# Video Products Technical Bulletin 30-2012-114R

SUBJECT: VIDEO DISTURBANCE OR NO VIDEO AT POWER-ON

MODEL: **LMD-1510W**  
**LMD-1530MD**  
**LMD-1530W**  
**LMD-2041W**  
**LMD-2110MD**  
**LMD-2110W**  
**PVM-1741**  
**PVM-2541**

**Figure 1**

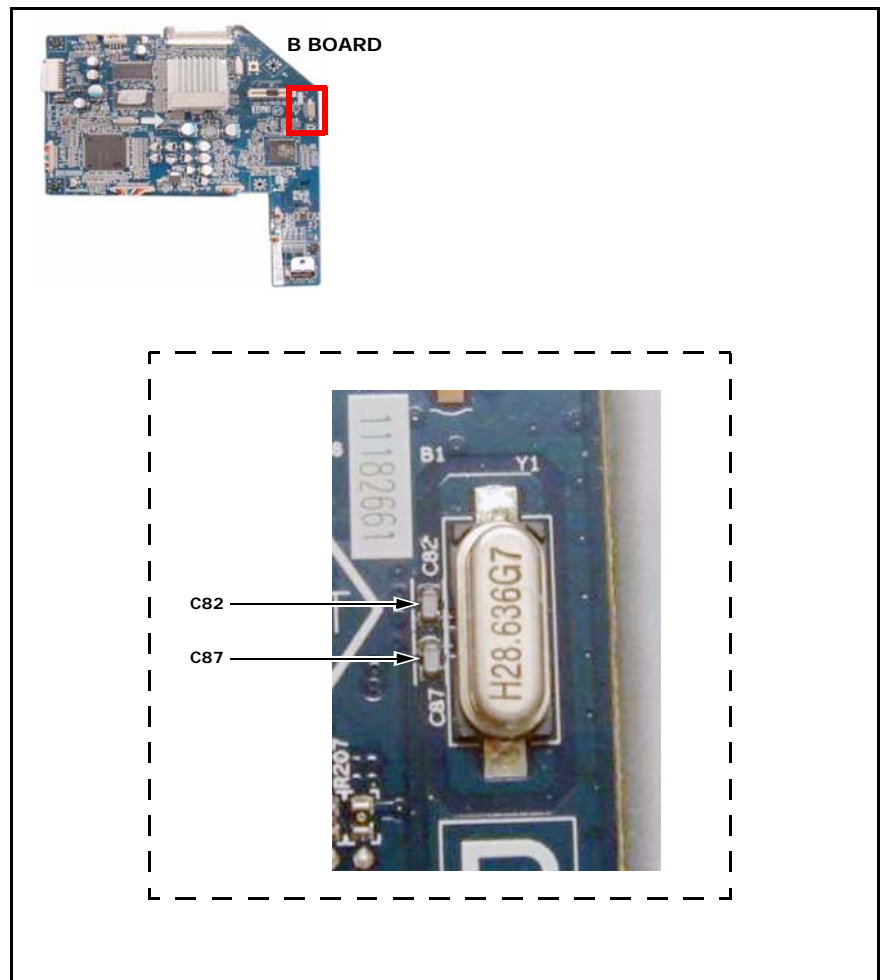
3. Replace C82 and C87 (18 pF) with new 5.6 pF capacitors.  
(See Figure 1.)

*Figure 2*

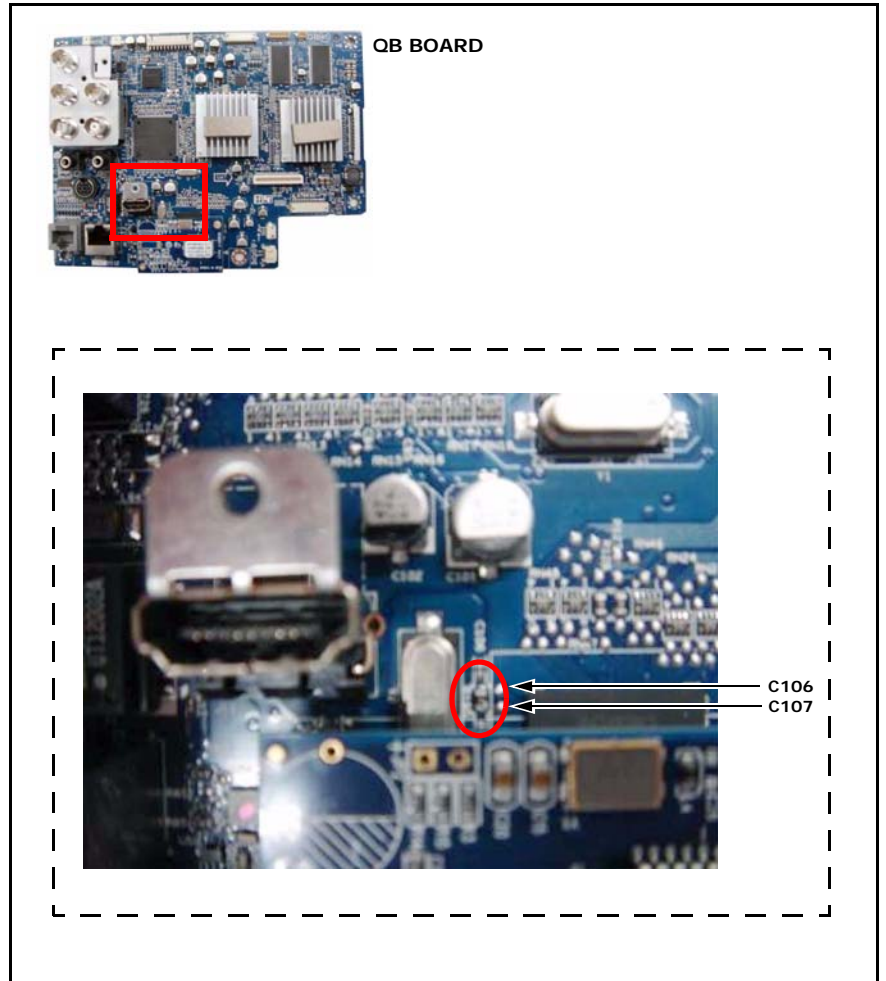
3. Replace C106 and C107 (22 pF) with new 12 pF capacitors.  
(See Figure 2.)
